**Humboldt County Resource Conservation District  
Russ Creek & Centerville Slough Restoration Project**

**Addendum #1**

**1 CUTOFF SLOUGH TIDE GATE IMPROVEMENTS PLAN**

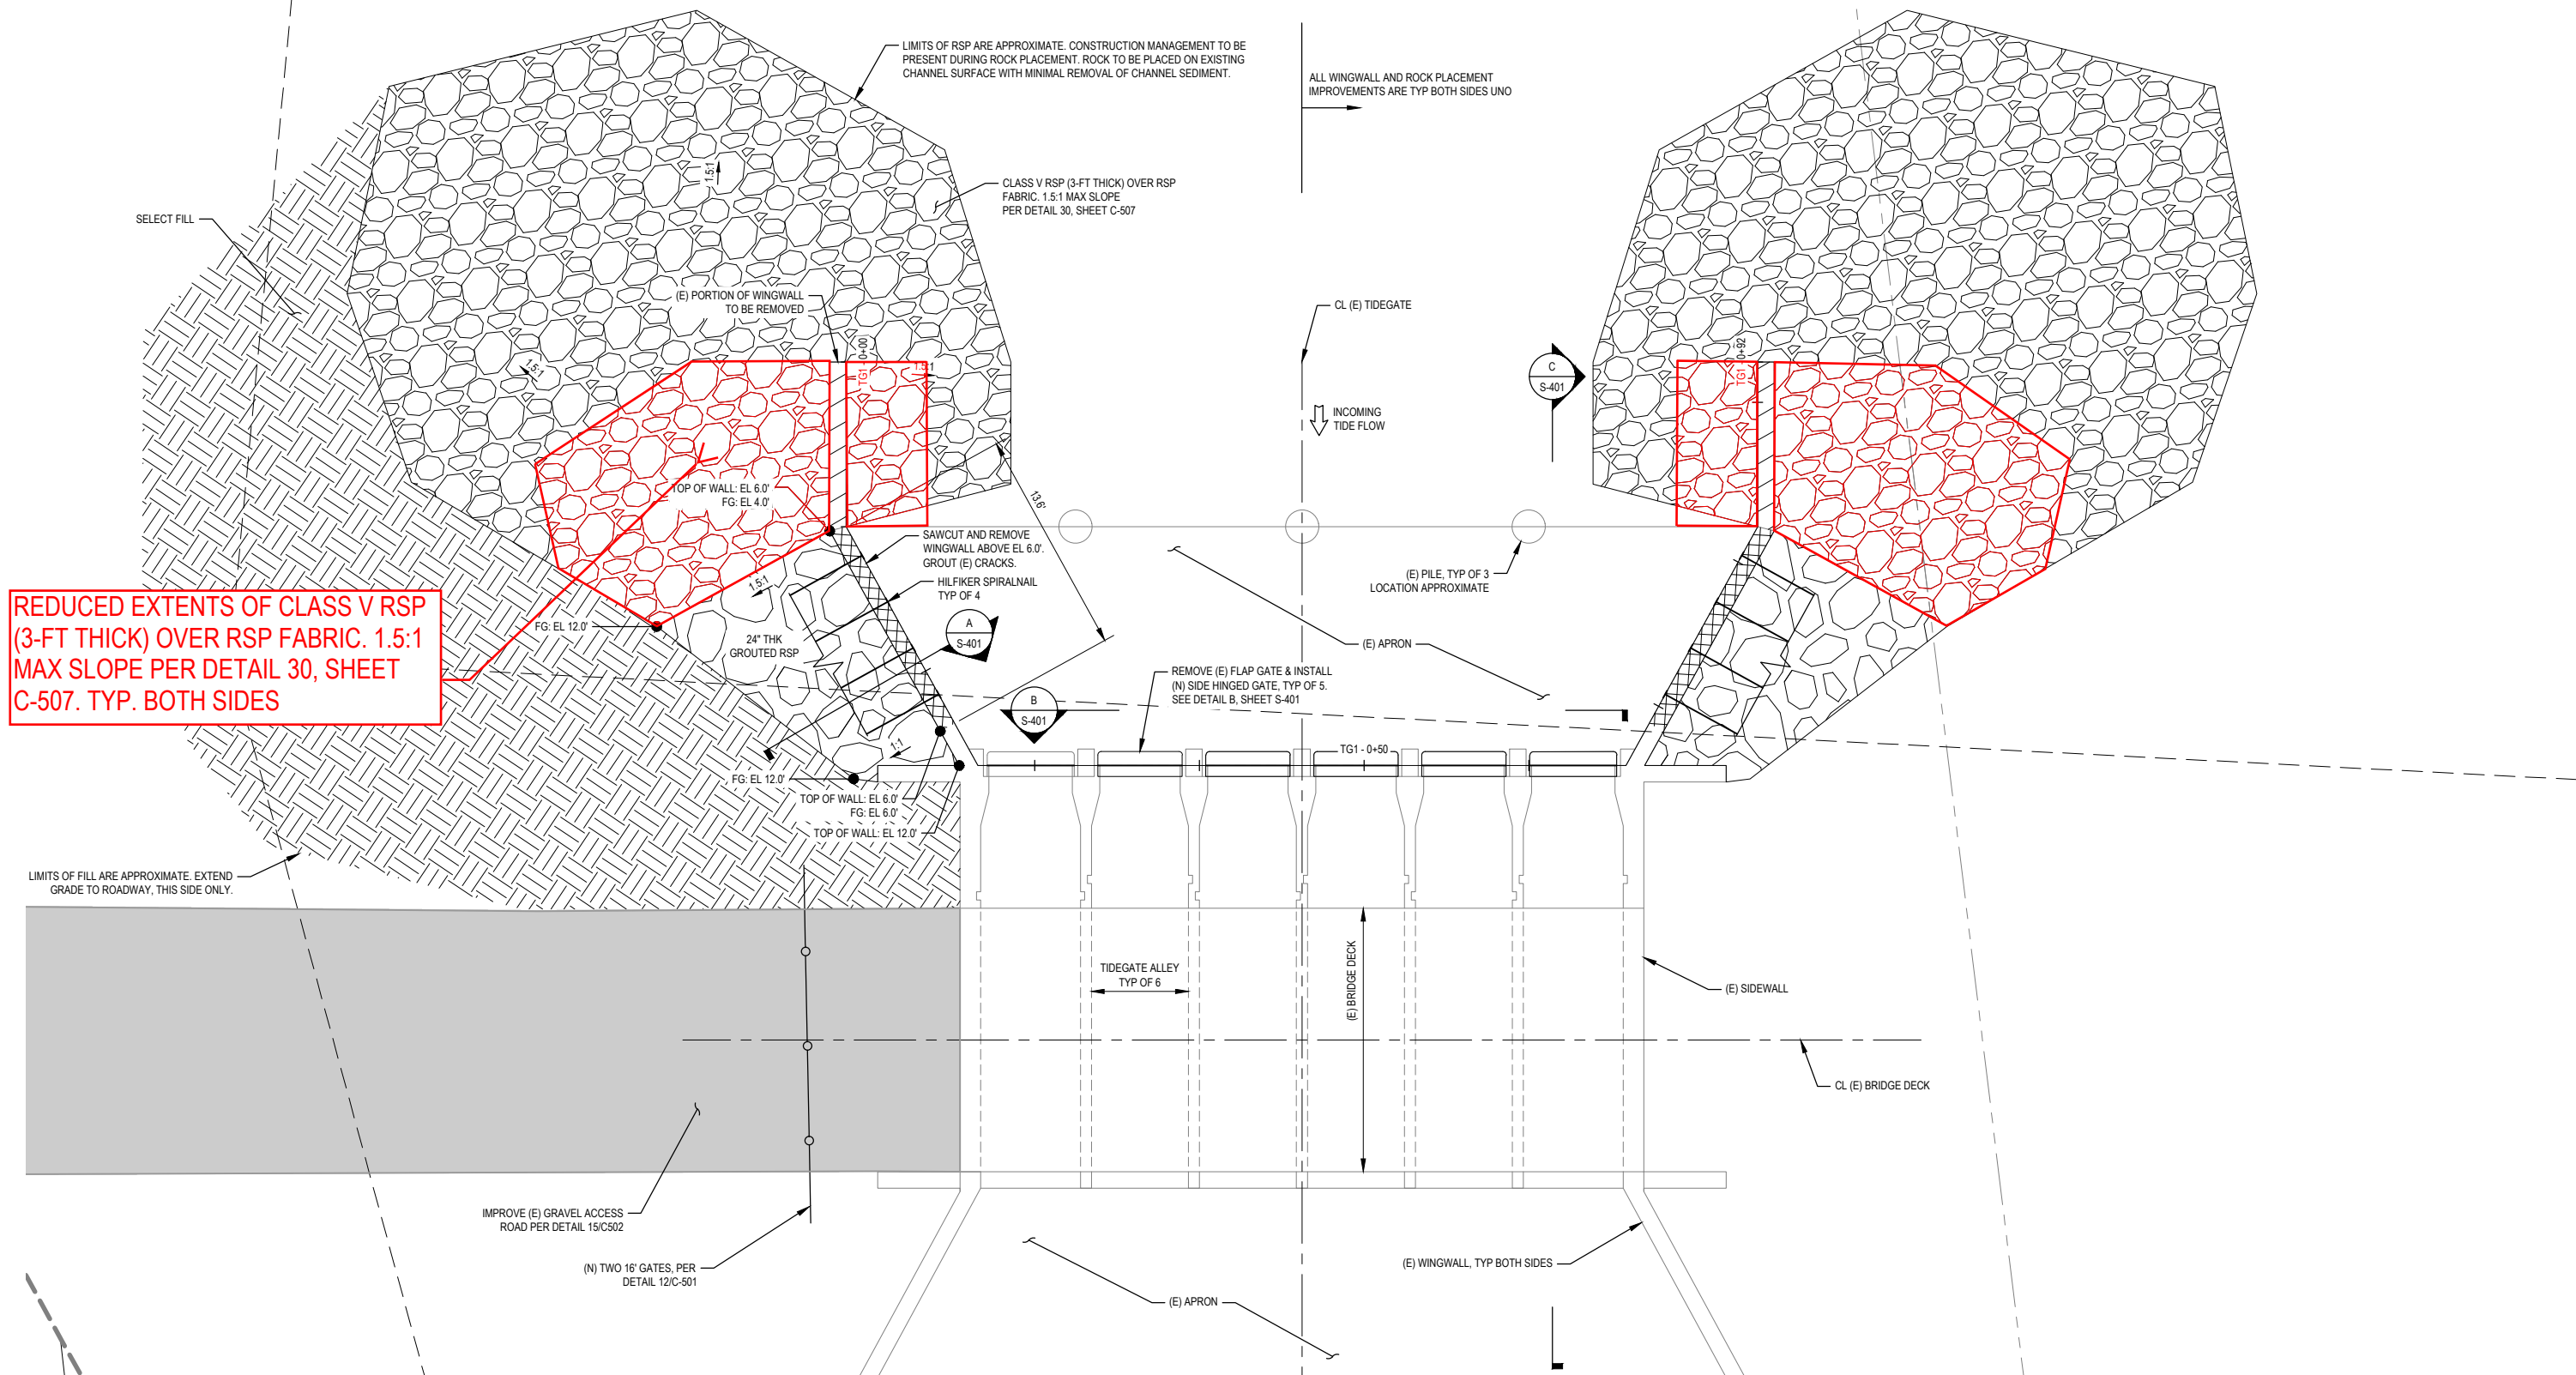
Item 1. REVISION: The extent of Class V Rock Slope Protection shown on sheet S-101 has been reduced. See attached revised sheet and reduced quantity in the bid schedule.

**REDUCED EXTENTS OF CLASS V RSP (3-FT THICK) OVER RSP FABRIC. 1.5:1 MAX SLOPE PER DETAIL 30, SHEET C-507. TYP. BOTH SIDES**
